APPLICATION NO.	FILING DATE	FIRST NAMED INVENTOR	ATTORNEY DOCKET NO.	CONFIRMATION NO.
09/929,350	08/15/2001	Jerome M. Eldridge	M4065.0454/P454	8862
24998	7590	09/10/2004	EXAMINER	
DICKSTEIN SHAPIRO MORIN & OSHINSKY LLP			CHU, CHRIS C	
2101 L STREET NW			ART UNIT	
WASHINGTON, DC 20037-1526			PAPER NUMBER	
			2815	
DATE MAILED: 09/10/2004

Office Action Summary	Application No. <u>09/929,350</u>	Applicant(s) ELDRIDGE ET AL.	
	Examiner Chris C. Chu	Art Unit 2815

DETAILED ACTION

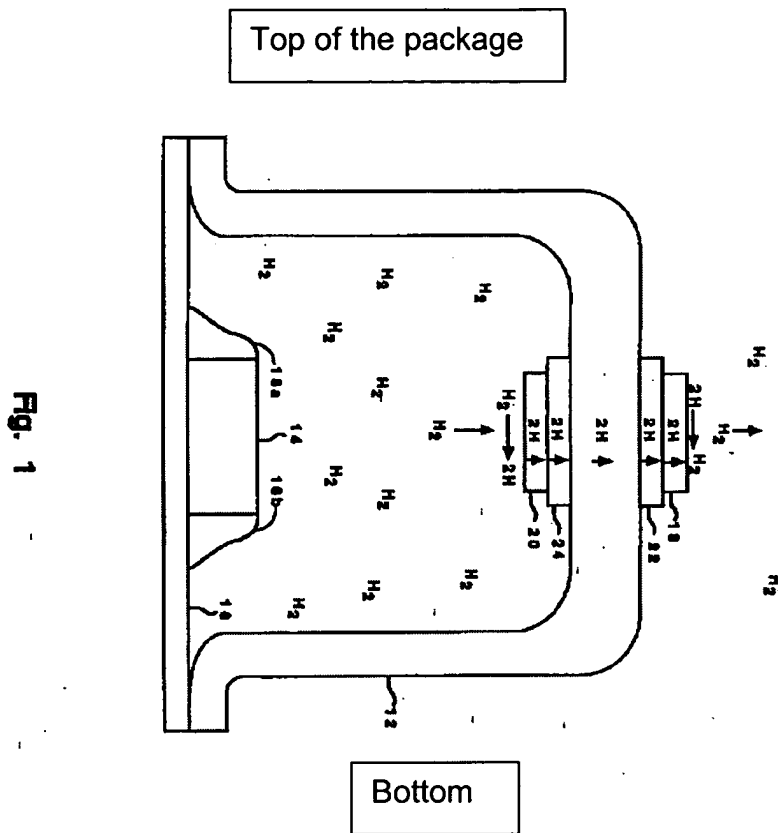
- a thin layer (16a) deposited over at least part of or partially covering said semiconductor chip (at the side view point of Fig. 1; see figure in page 13 of this Office action) comprising a source of releasable hydrogen (column 5, lines 1 - 10) within said enclosure.

On page 38, applicant argues "Stupian does not teach the limitations of claim 37 or claim 88. Claims 37 and 88 recite 'a thin layer deposited over at least part of said semiconductor chip comprising a source of releasable hydrogen within said enclosure.' ... claims 37 and 88 is 'deposited over at least part of said semiconductor chip,' not on the wall of the package." This argument is not persuasive. Stupian clearly shows in Fig. 1 that the thin layer (16a) deposited over at least part of said semiconductor chip (14).
